XtremeAir GmbH, Harzstr.2, D-39444 Hecklingen Tel: +49 39267 60999 0, Fax: +49 39267 60999 20 www.xtremeair.de info@xtremeair.de	SB-2013-008
		Ausgabe: A.04
DOA-Nr.: EASA.21J.360	Service Bulletin SB-2013-008	Date: 01.07.2014

Subject: Engine Mount

Aircraft model affected: XA42, XA41

Figure 1: Welding seams area where extra attention is needed during inspection

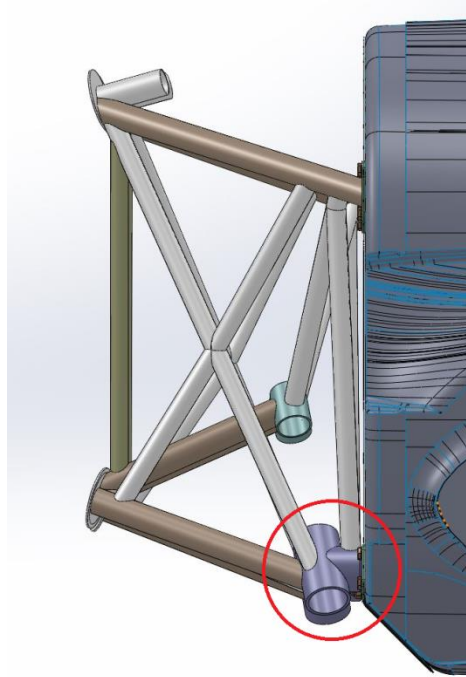
Note: Particularly the welds between the lower landing gear attachment bearing and the lower engine mount to firewall attachment-plate are susceptible to cracking in aircraft operated regularly from rough airfields. Figure 1 and 2.

3. When in doubt, perform a dye penetrant inspection, refer to AC 43.13-1B.
4. If cracks are found, replace the engine mount before next flight.
5. Reinstall the engine cowling.
6. Repeat the above inspection after every 10 flights.
